寄件者: Louis Tse [REDACTED]
寄件日期: 2026年02月04日星期三 18:11
收件者: tpbpd/PLAND
副本: Andrea Wing Yin YAN/PLAND; Ivan Sze Yuet FUNG/PLAND; Bon Tang; Matthew Ng;
Christian Chim; Danny Ng; Grace Wong
主旨: [FI] S.16 Application No. A/YL-KTN/1180 - FI to address departmental comments
附件: FI2 for A_YL-KTN_1180 (20260204).pdf
類別: Internet Email

2nd Further Information

Proposed Temporary Warehouse (Excluding Dangerous Goods Godown) with Ancillary Facilities and Associated Filling of Land and Pond for a Period of 3 Years in "Agriculture" Zone, Various Lots in D.D. 107 and Adjoining Government Land, Kam Tin, Yuen Long, N.T.

(S.16 Planning Application No. A/YL-KTN/1180)

Drawing No. W1010/112	Stage P	Rev. A
---------------------------------	-------------------	------------------

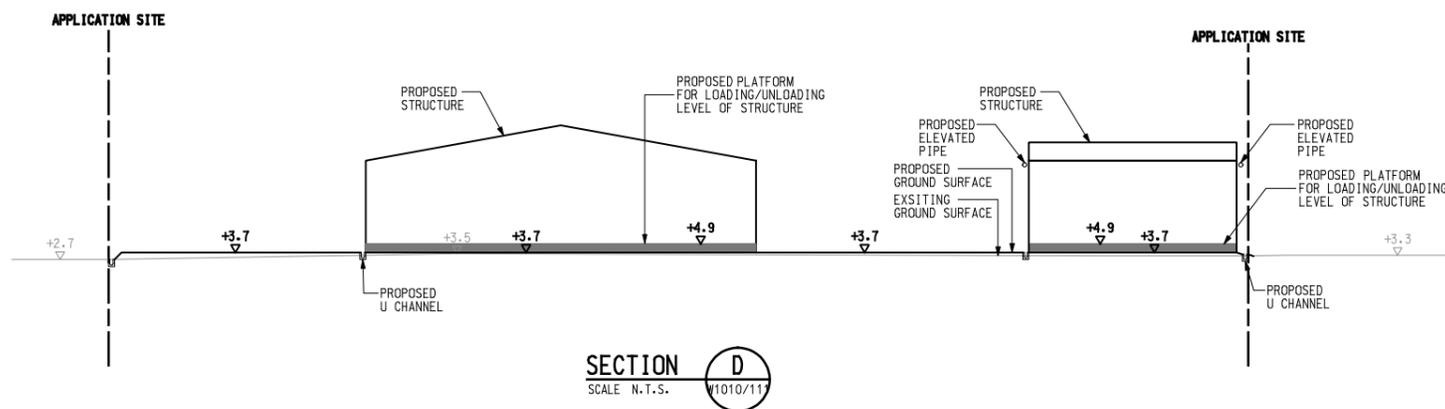
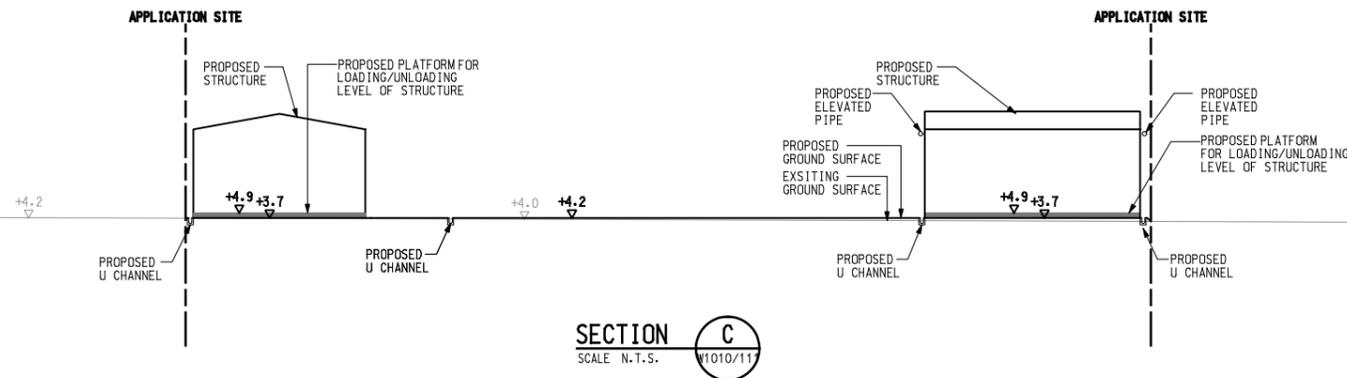
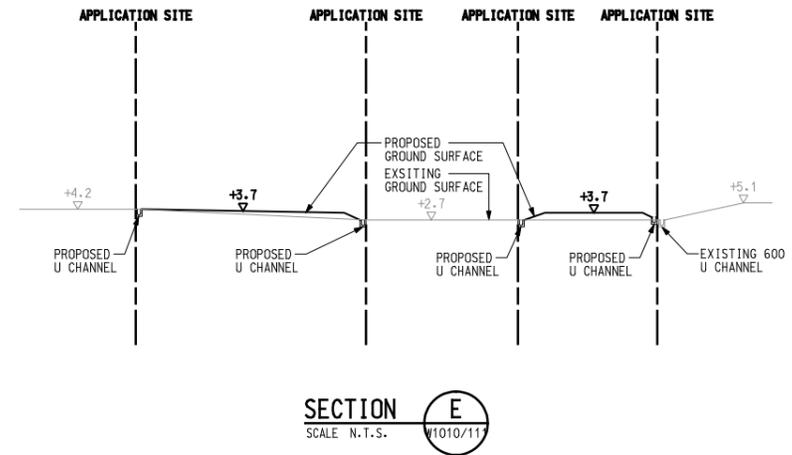
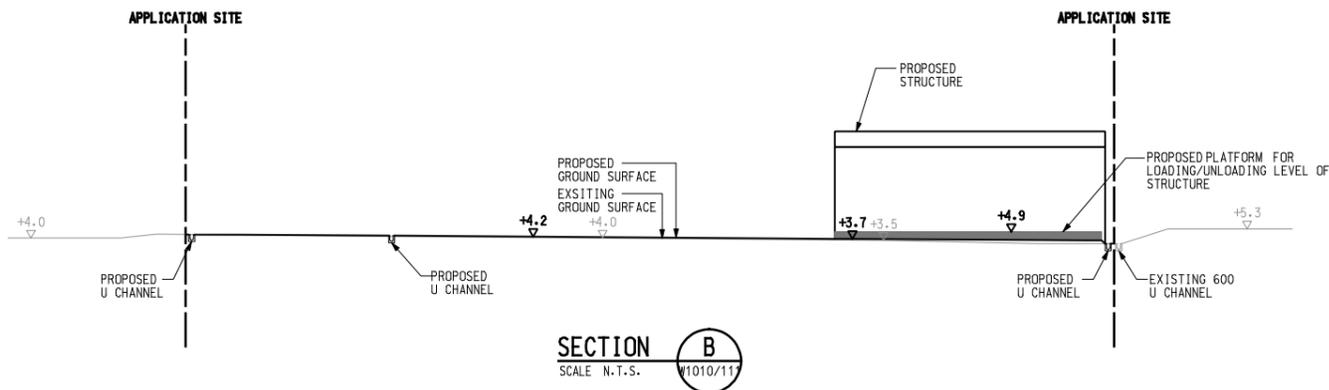
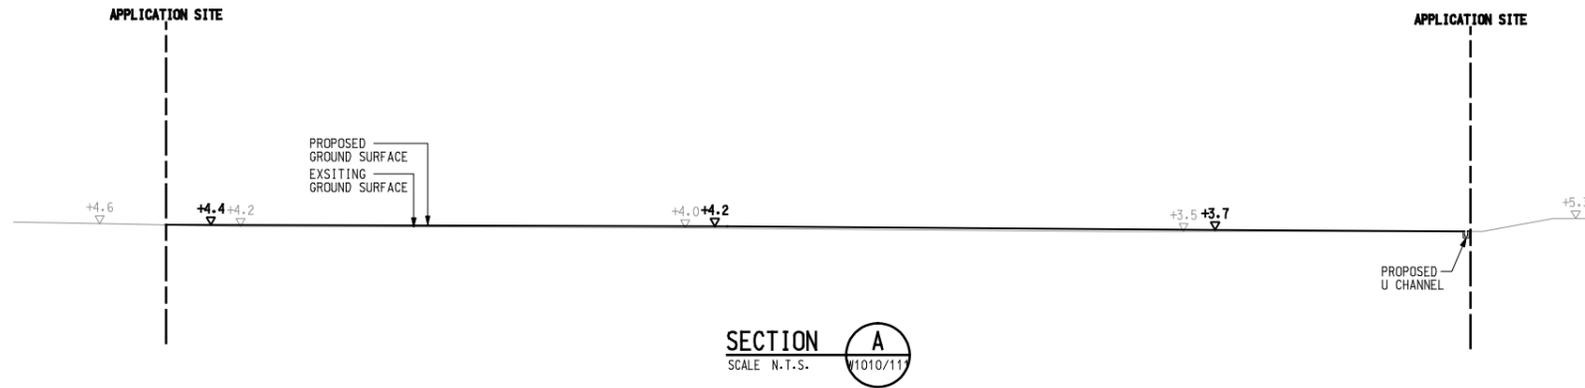
(2)	<p>Cross sections showing the proposed drainage facilities and existing and proposed ground levels of the captioned site with respect to the adjacent areas should be given. Some information is missing in the submitted cross sections. Also, the applicant should clarify discrepancy of the proposed surface channels shown in the submitted drainage plan and Section C.</p>	<p>The cross sections in drawing no. W1010/112 have been revised to show the proposed drainage facilities along with the existing and future ground levels of the captioned site with respect to the adjacent areas.</p> <p>The surface channel presented in Section C has been deleted to be consistent with the proposed drainage plan.</p>

Drawing No. W1010/113	Stage P	Rev. A
---------------------------------	-------------------	------------------

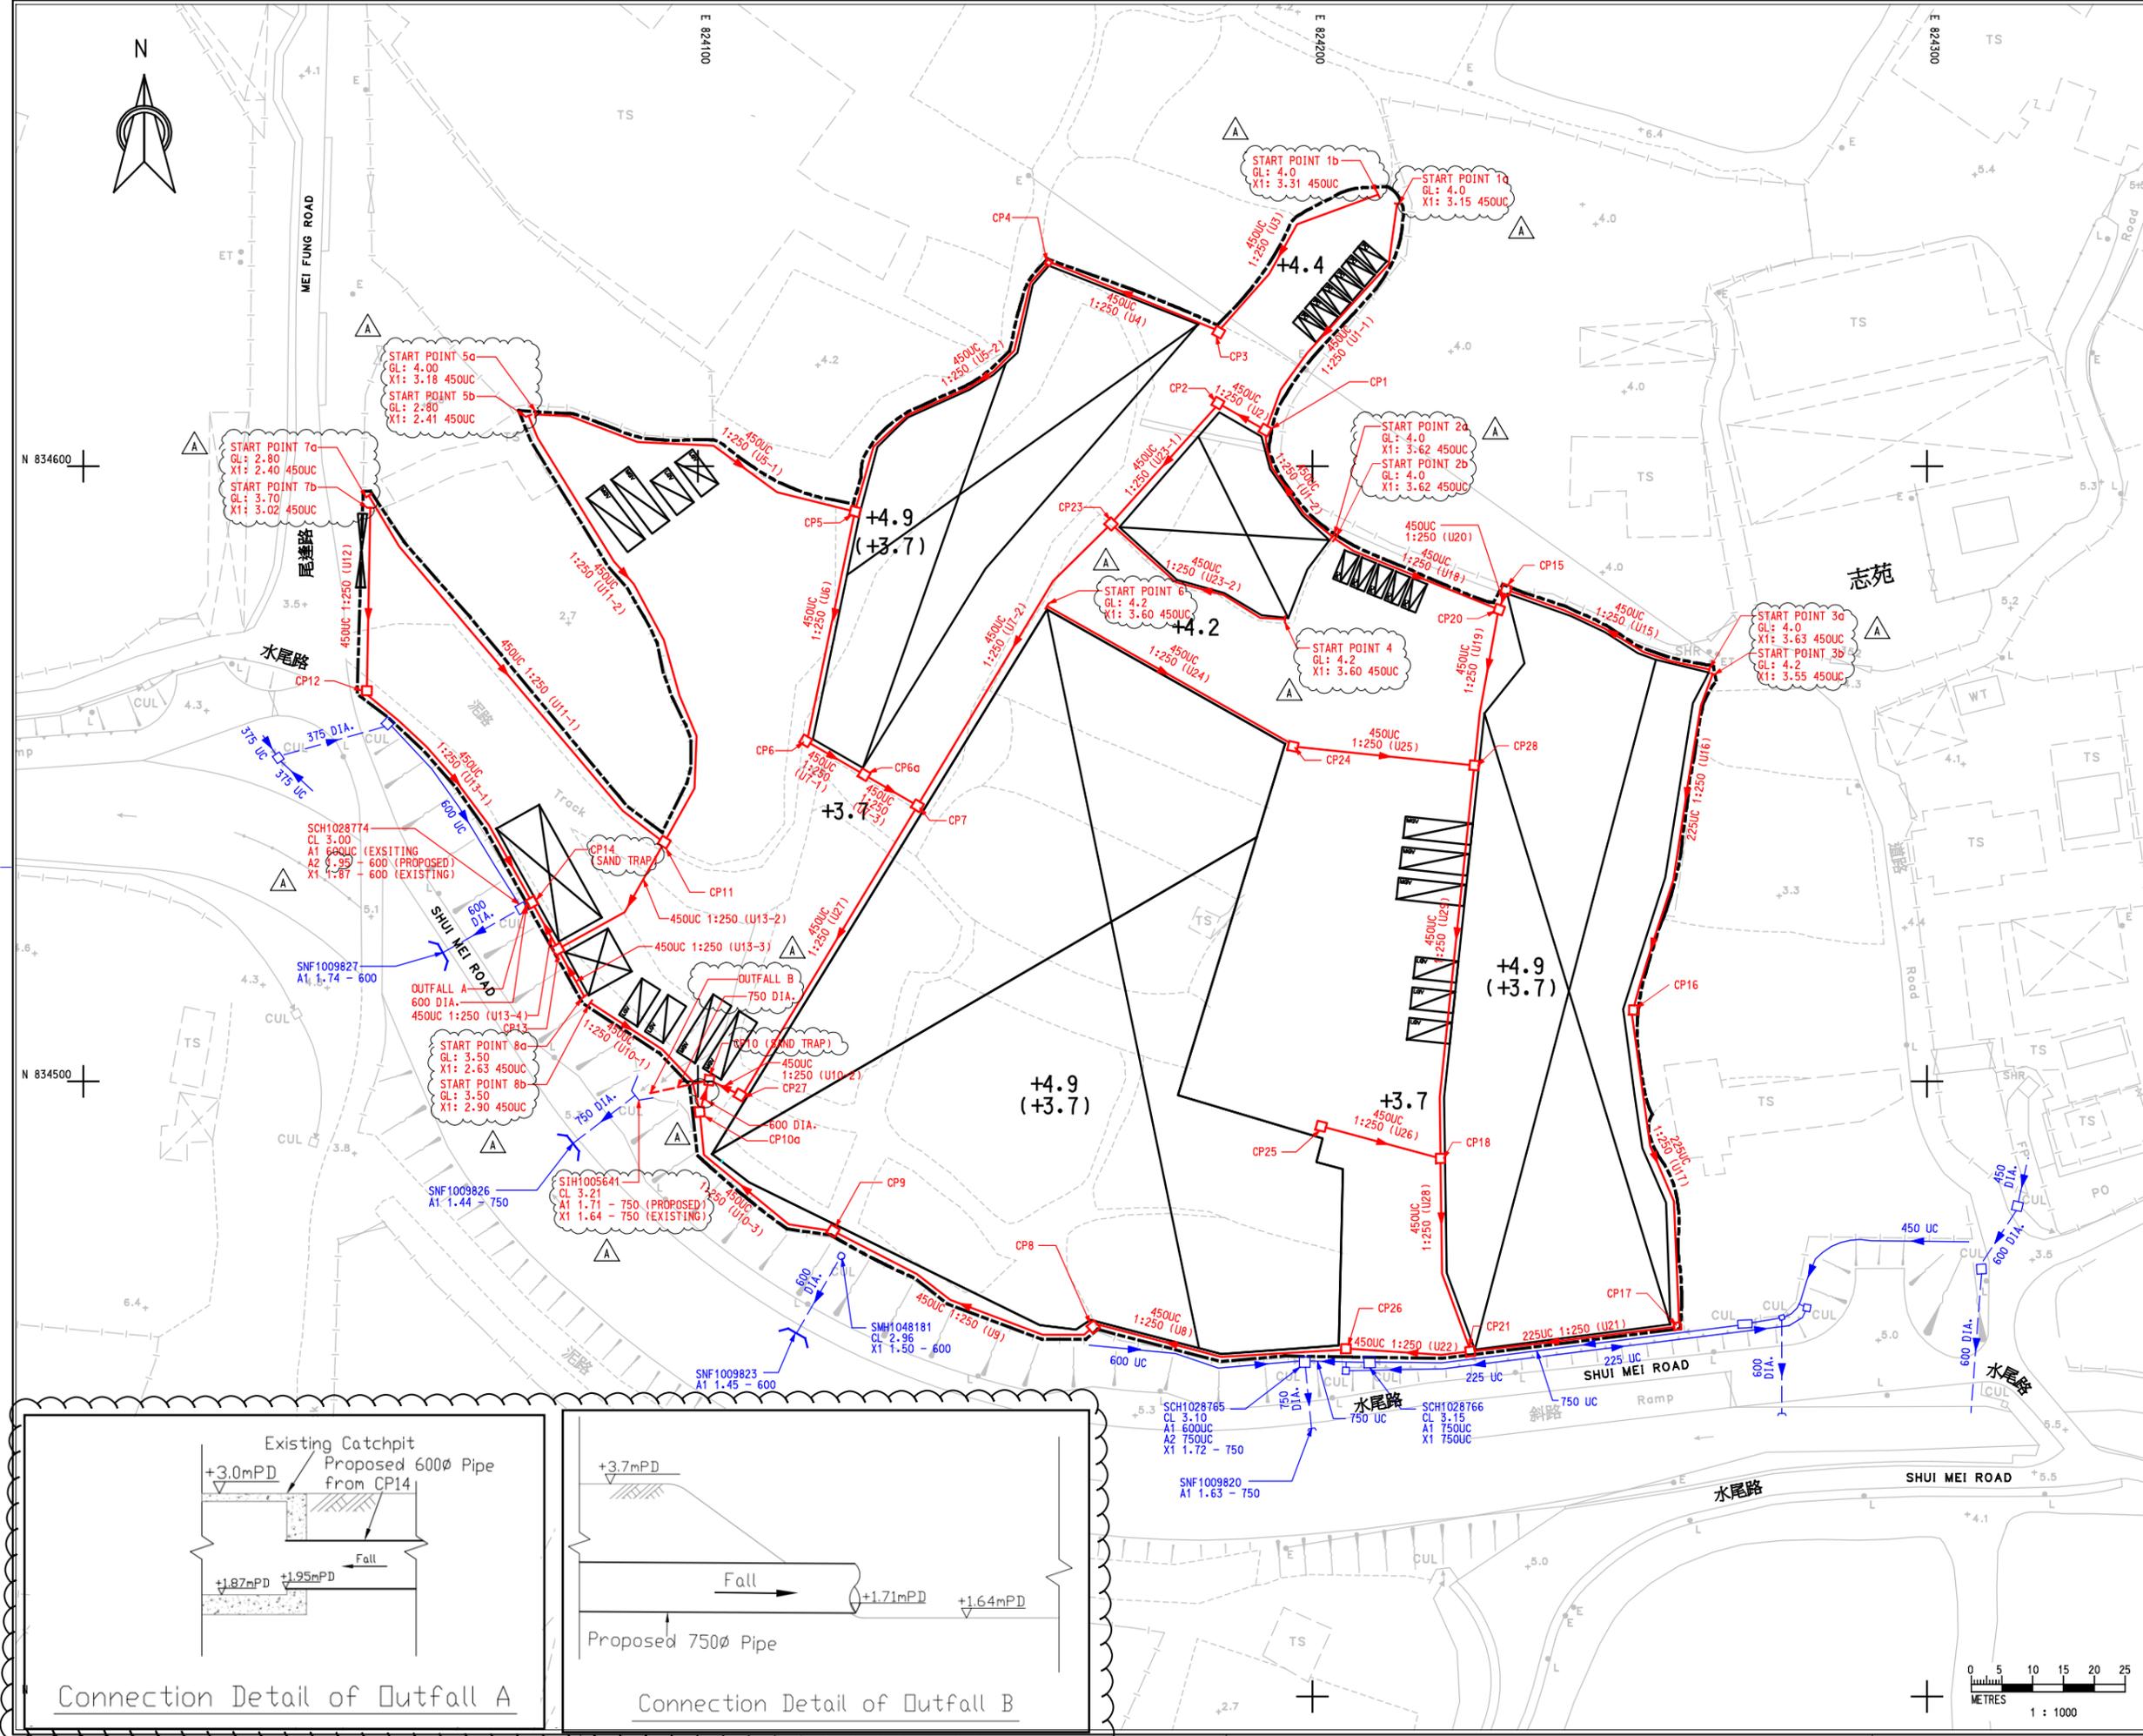
(4)	The applicant should clarify invert levels at the starting point of the proposed surface channels.	The invert levels at the starting point of the proposed surface channels are shown on the drawing no. W1010/113.

(5)	The applicant should provide details for the connection of the proposed and existing drainage system at outfalls A, B and C.	Details of the connection of outlets A, B and C to the existing drainage system are shown in drawing nos. W1010/113 and W1010/114.

(10)	<p>Drawing (No.: W1010/113) & Appendix B:</p> <p>The applicant should clarify discrepancy of invert level of the proposed 600mm dia. stormwater pipe at the connection to existing catchpit SCH1028774.</p>	<p>The invert level of the proposed 600mm dia. stormwater pipe at the connection to the existing catchpit SCH1028774 is +1.95 mPD, which it is shown in the drawing no. W1010/113.</p>

(11)	<p>Sand trap or provision alike should be clearly indicated on the proposed drainage plan and provided before the collected runoff is discharged to the public drainage facilities.</p>	<p>The catchpits/manhole with sand trap before the collected runoff is discharged to the public drainage facilities which they are indicated on the drawing nos. W1010/113 & 114.</p>

(12)	<p>Drawing (No: W1010/113):</p> <p>The applicant should review invert level of surface channels at the connection to the proposed catchpit CP 10a. Invert level of drainage facilities at the upstream should be higher than that at the downstream.</p>	<p>Please note that the invert level of the drainage facilities at the upstream are higher than that at the downstream catchpit CP 10a, which they have been shown in the drawing no. W1010/113 of the previous submission.</p>

Drawing No. W1010/115	Stage P	Rev. A
---------------------------------	-------------------	------------------

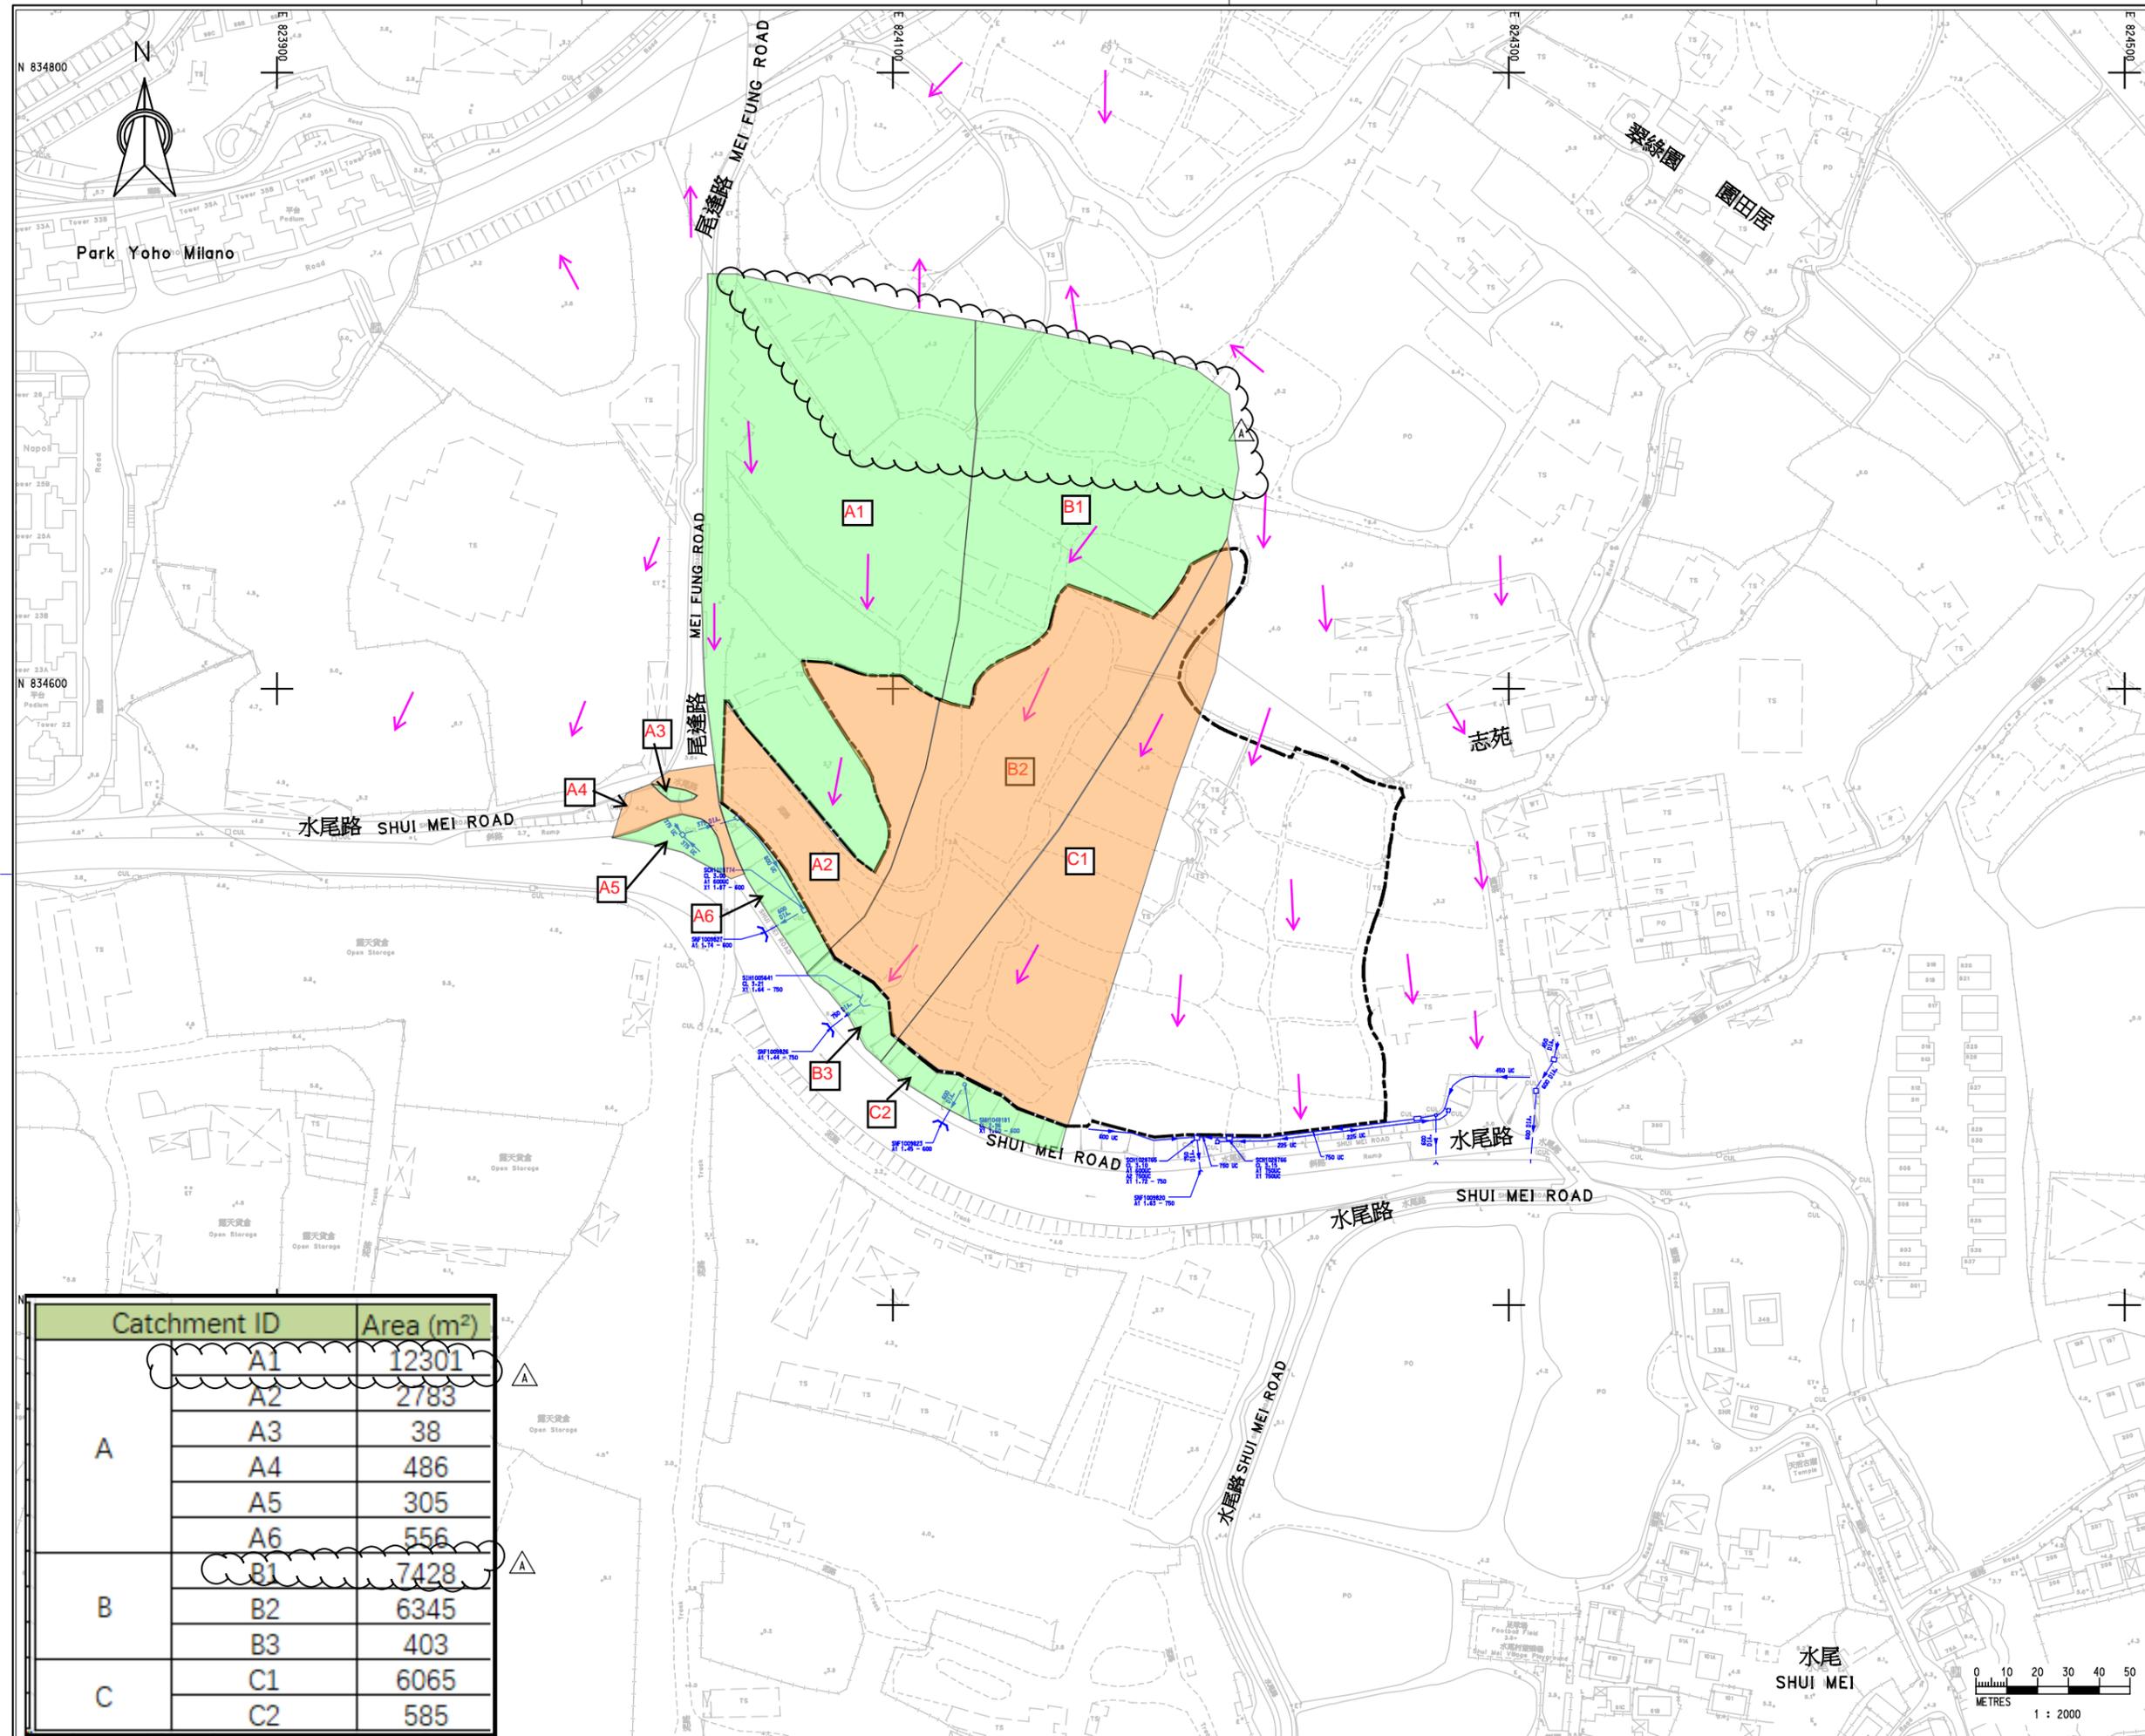
(A) Specific Comments		
(1)	<p>The ground to the north and northeast of the application site is generally higher. According to the topography around the subject site, external catchment area shall be greater than the one adopted in the submitted hydraulic calculation. The applicant should update hydraulic calculation.</p>	<p>A revised drainage impact assessment (DIA) is provided by the applicant to review the drainage arrangement for the proposed development (Annex III).</p> <p>We have further expanded the catchment area in this study to cope with the site at the north and northeast of the project site based on the available topographic information.</p> <p>The corresponding hydraulic calculation in Appendix B has been also updated based on this revised catchment area, which it is shown in the drawing nos. W1010/115 & 116.</p>
